Product/Process Change Notification

| Initiator/Title/Date: | Teng.Cao Jul.30,2020       | PCN No.: | PCN-20018 |

| Amphenol P/N | ME1005610201031<br>ME1008410201031<br>ME1014010201031<br>ME1016810201031<br>ME1016810201032 | Customer P/N | N/A | Description | Mini Cool Edge Right Angle 4.05 Seating Height Connector |

|             | <div><p>Take the 140pin connector for example</p></div> | <div><p>Take the 140pin connector for example</p></div> |

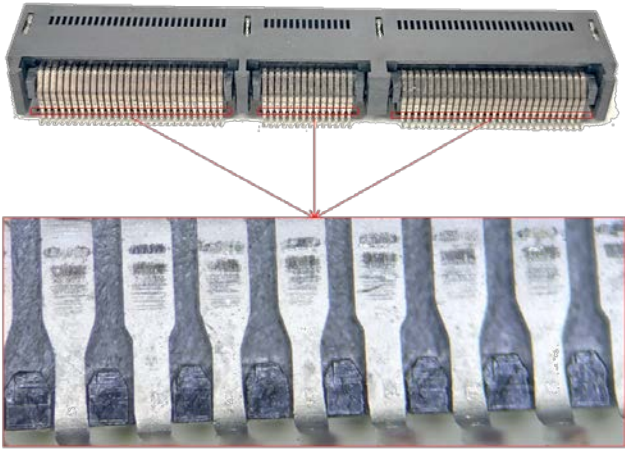
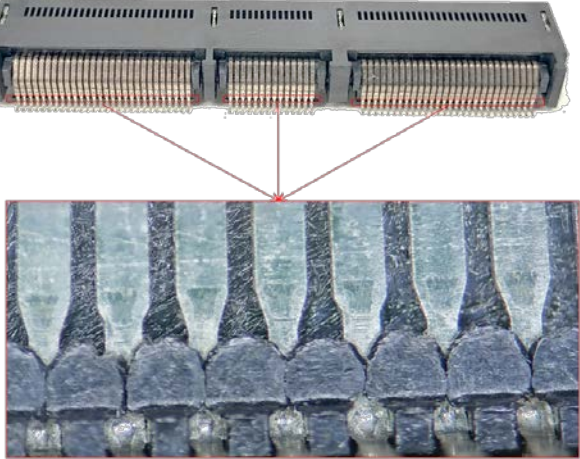
| Reason of Change | To enhance the product coplanarity stability, Add 'hot staking' process to fix the top contact that will not impact customer application(Form,Fit and Function). |

| Description | Before change applied  | After change applied  |
